Felsted Parish Council
Parish Council Office
URC Hall
Stebbing Road
Felsted
CM6 3JD
7th August 2014

Re: NATS consultation 'Departure Route proposal at London Stansted Airport'.

Figure 1 Stansted Airport Departures to the South and East - Proposed Areas of Change

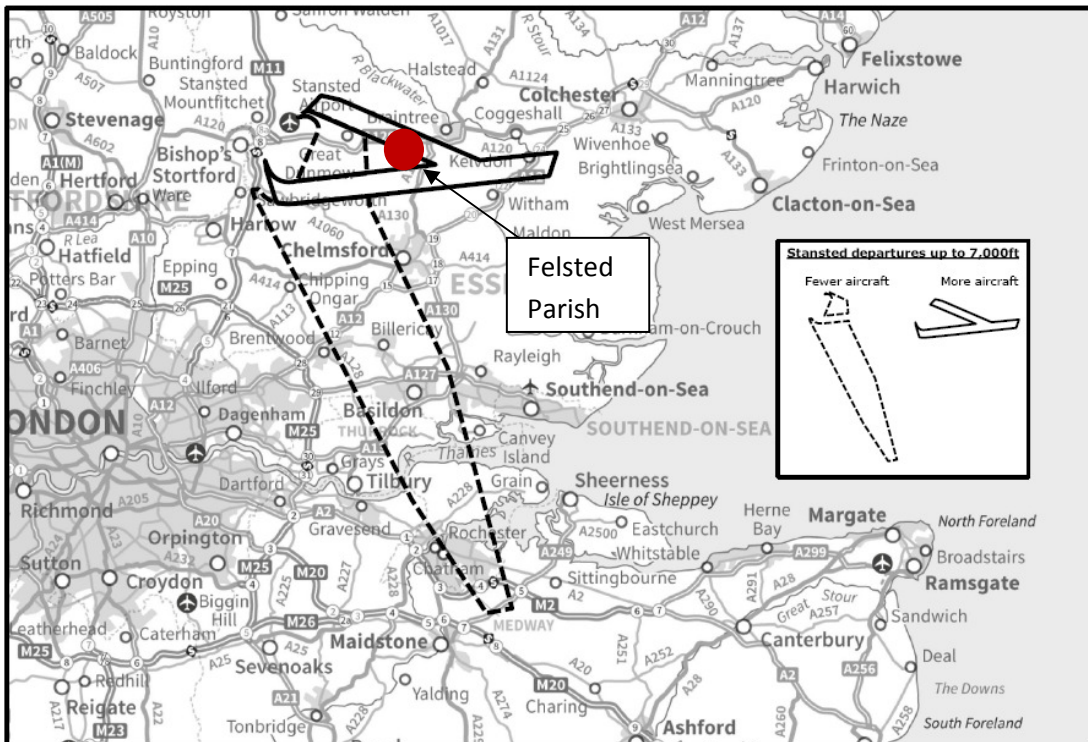
The NATS summary leaflet (ref 4 and repeated below) indicates changes where land in a dotted area will see fewer flights, whereas areas indicated by a solid line would be subject to additional flights. The differences in the footprints covered by these 2 areas are significant, in the order of 7 times. So, under this proposal, **not only will the 2 Clacton routes see an increase in flights, with a 63% increase in those affected by flights under 4000ft, they will also be subjected to an intensity of 7 times the flight 'load' from these flights** compared to that currently experienced when they use the Dover route. This is on top of the flights already using the Clacton route.

Where is the analysis of the impact of increased air and noise pollution for these areas? There isn't a single reference to air pollution analysis, specifically NOX related pollution levels.
